Re: Indian Point Unit 2
Docket No. 50-247
NL-04-039

Subject: **Supporting Information for License Amendment Request Regarding
Indian Point 2 Stretch Power Uprate (TAC MC 1865)**

**ANSWERS TO QUESTIONS REGARDING
REVIEW BY PLANT SYSTEMS BRANCH
PER CONFERENCE CALL OF 2/18/2004
AND DISCUSSIONS AT THE MARCH 9 PUBLIC MEETING**

Indian Point 2 Setpoint and Allowable Value Determination

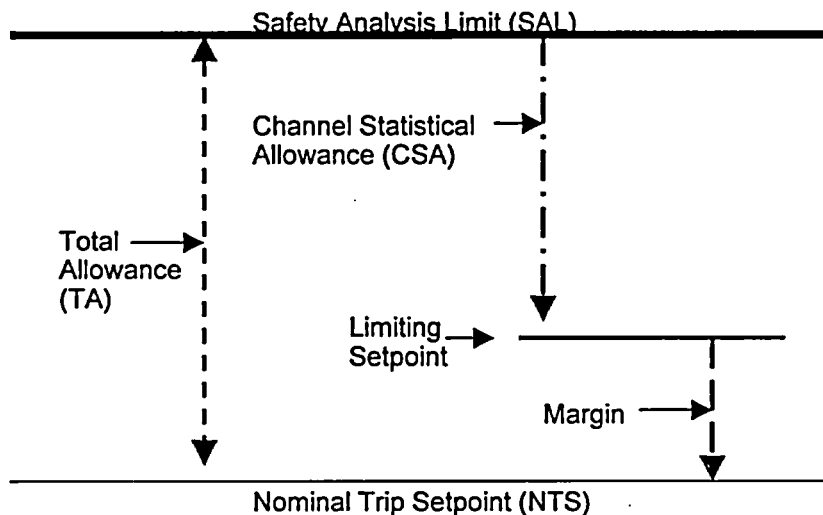
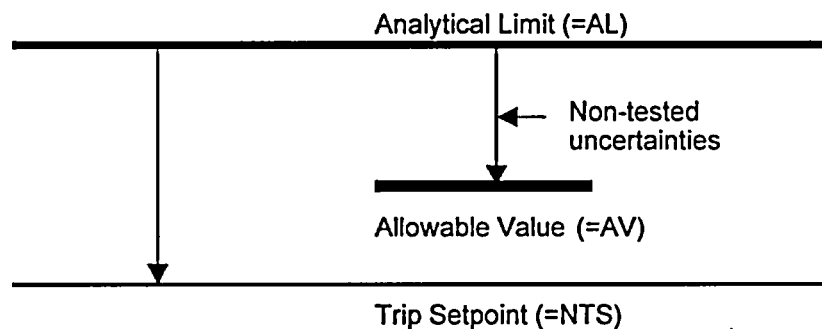
5 The NRC staff has recently become aware, and has discussed with NEI, a problem with use of instrument setpoint methodology if based on "Method 3" of ANSI/ISA-S67.04, "Setpoints for Nuclear Safety-Related Instrumentation." Does Indian Point 2 use this method? In describing the setpoint methodology used for IP2, please provide additional information associated with how channel operability is determined.

The methodology used for determining technical specification allowable values (AV) for the IP2 protection systems (RPS and ESFAS) is described in Entergy Specification FIX-95-A-001, Revision 1 which was submitted to the NRC in Entergy letter NL-03-117, dated July 18, 2003, as part of the license amendment for conversion to the Improved Standard Technical Specifications. This specification establishes a methodology equivalent to that described in ISA RP67.04, Method 2.

Per ISA RP67.04 the Allowable Value in Method 2 "...is determined by calculating the instrument channel uncertainty without including...drift, calibration uncertainties, and uncertainties observed during normal operations...This result is then subtracted from the analytical limit (AL) to establish the AV...the trip setpoint is determined as described in 7.2." Section 7.2 of RP67.04 describes a setpoint determination methodology similar to that described above for IP2.
